STATE OF MAINE
DEPARTMENT OF TRANSPORTATION
16 STATE HOUSE STATION
AUGUSTA, MAINE
04333-0016

February 11, 2010
Subject: **Boothbay**
State Pin No: 012630.00
Amendment No. 3

KNICKERBOCKER BRIDGE
BACK RIVER
BOOTHBAY
LINCOLN COUNTY

STATE OF MAINE
DEPARTMENT OF TRANSPORTATION
BRIDGE NO. 2438
PIN
BR-1263(000X)
12630.00

PIER NOTES

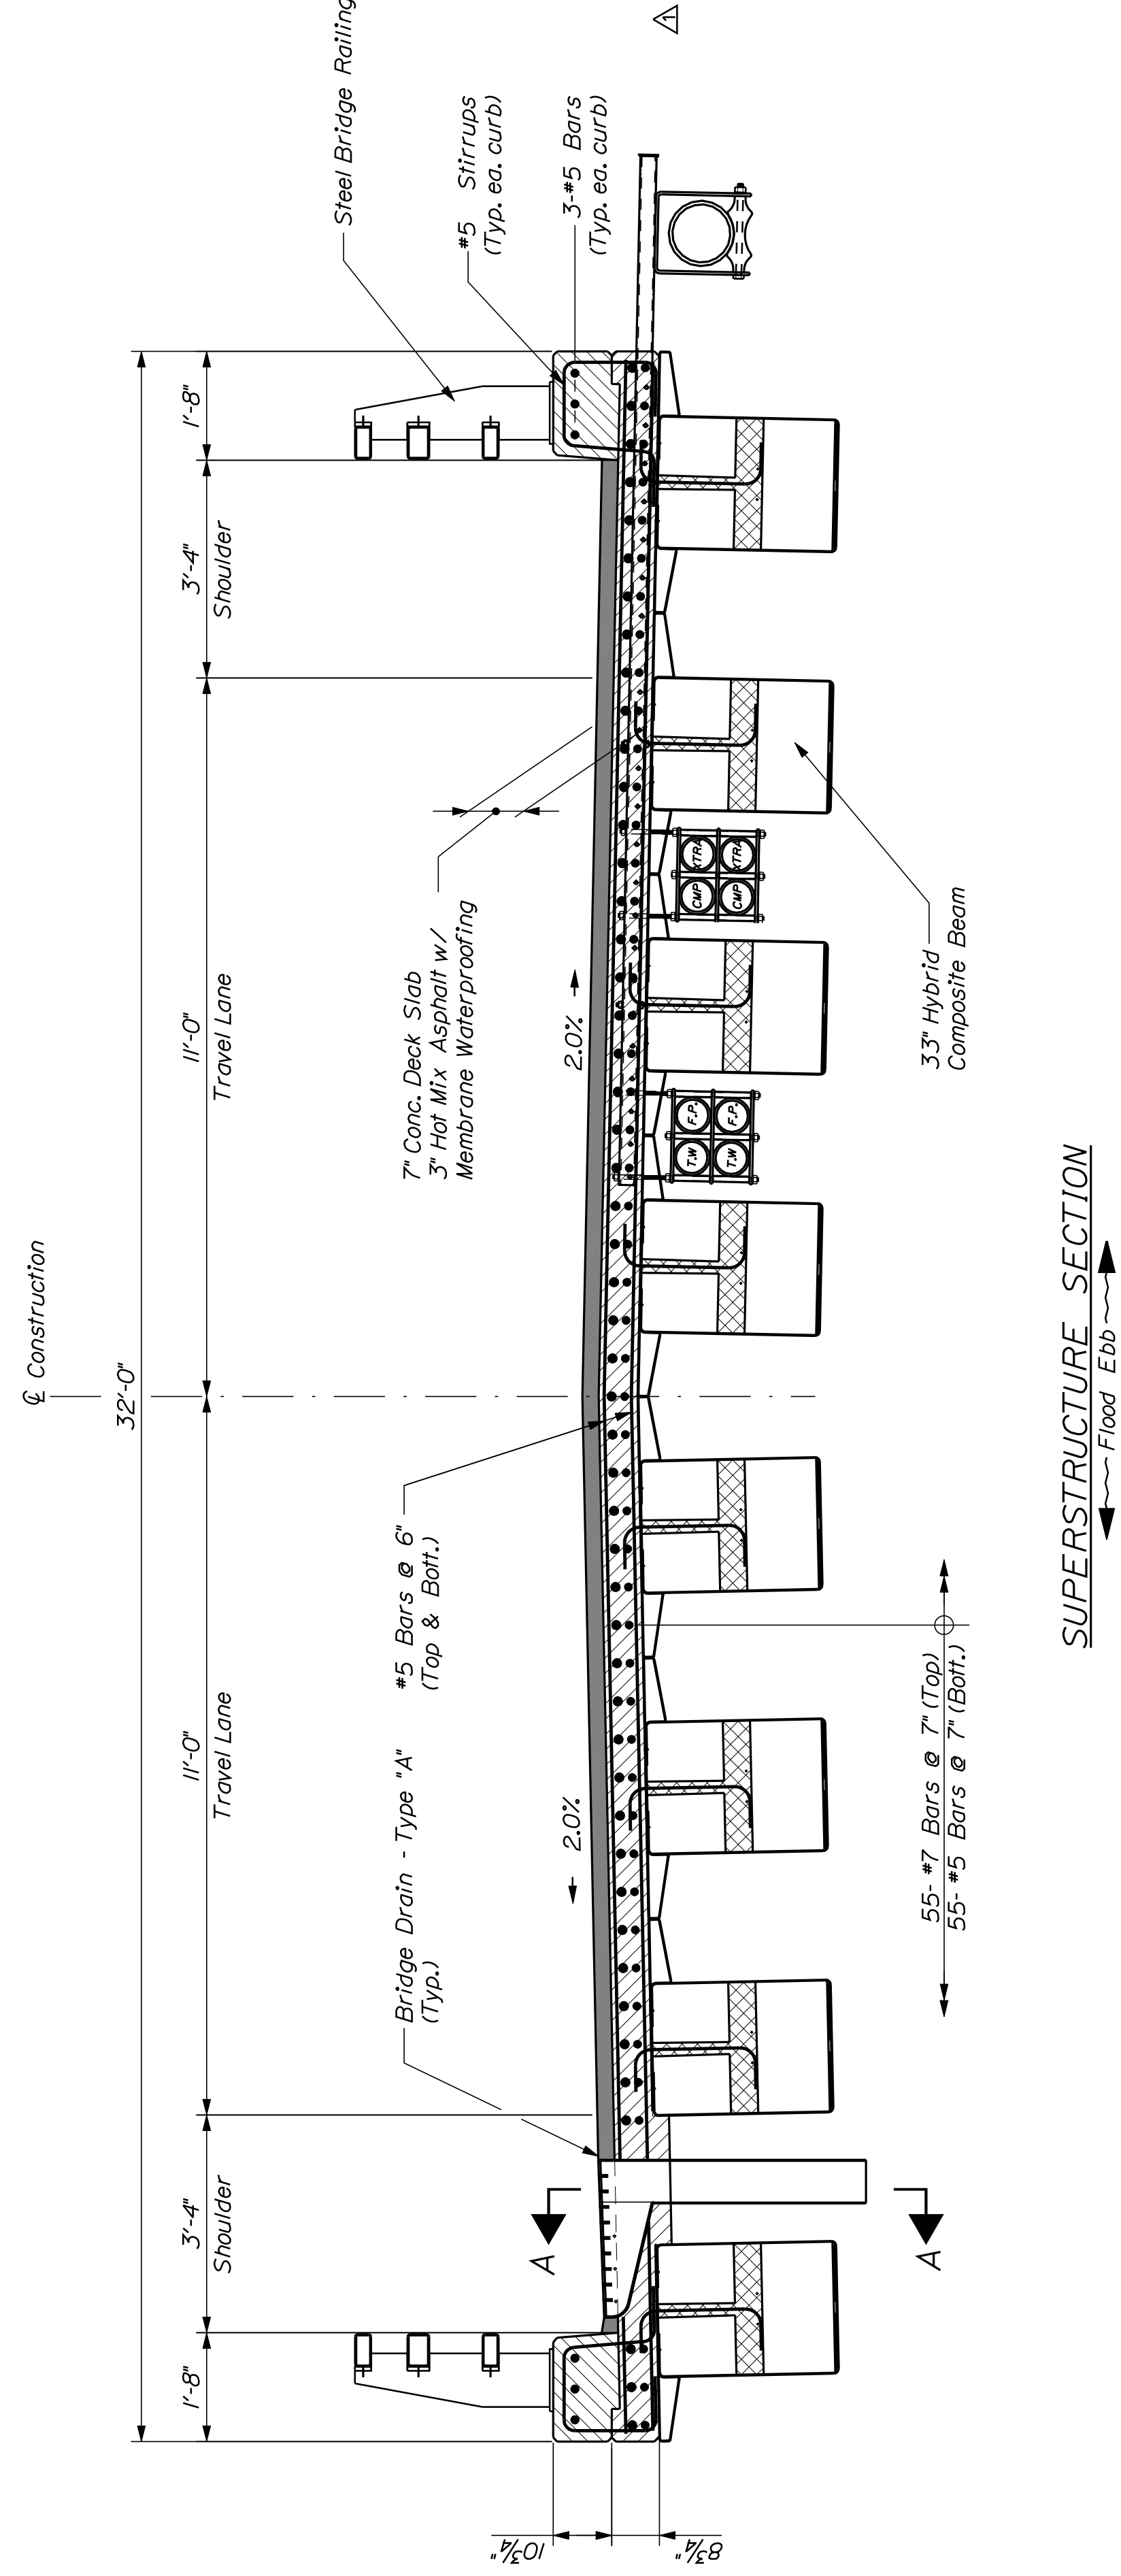
REMOVE SHEET NUMBER 29 OF 51 and **REPLACE** with the attached new SHEET NUMBER 29 OF 51

Question: Define side bars shown in pier cap x section – not shown pier cap reinf.?

Response: Side bars shown in section for the pier cap shall be continuous #7 bars as shown at the bottom of the pier cap.

SUPERSTRUCTURE SECTION

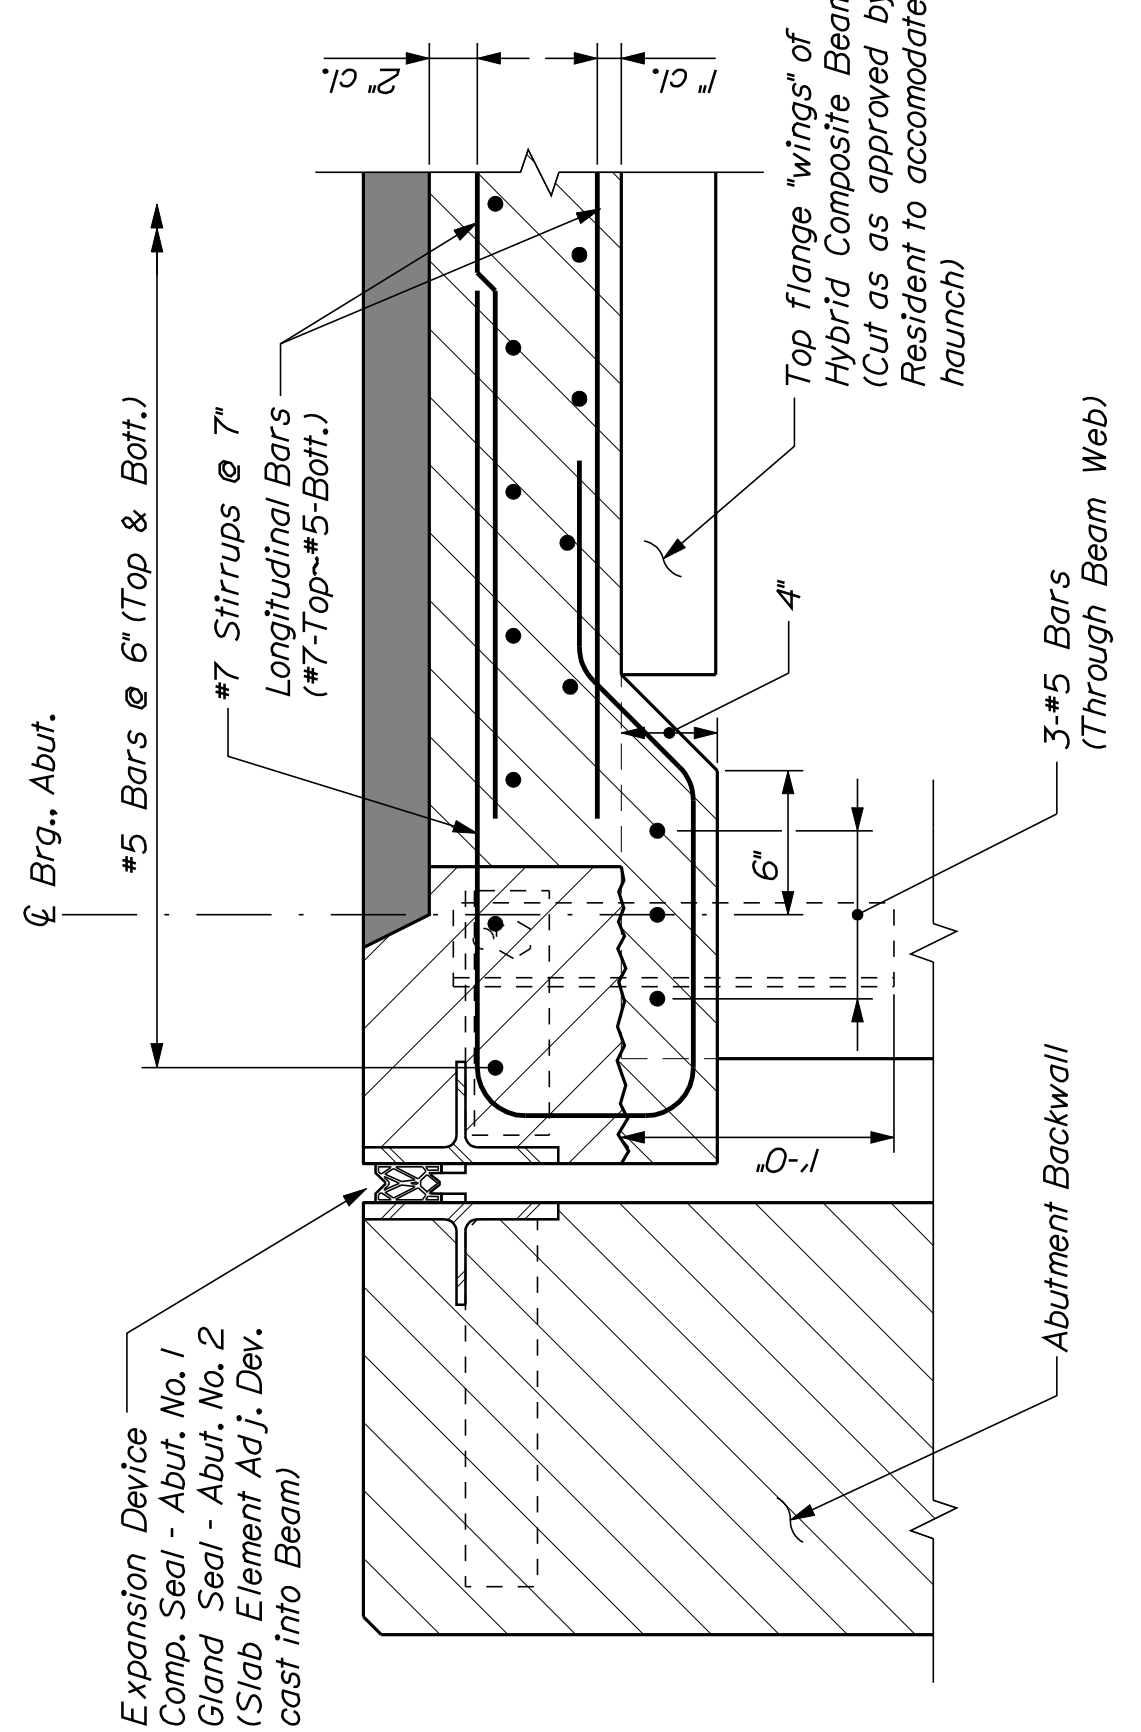
Question: Need details on how conduit systems pass through Pier Diaphragms & Abut Back walls.

Question: Please refer to pages 26, 27, 28 and 51 of the Plans. How do the conduit ducts go through the abutments and pier caps?

Response: Conduit pass through details at the diaphragm and backwalls are provided in the attached drawing.

Response: We are correcting the plans to show how this is done. Please see the bid amendment.
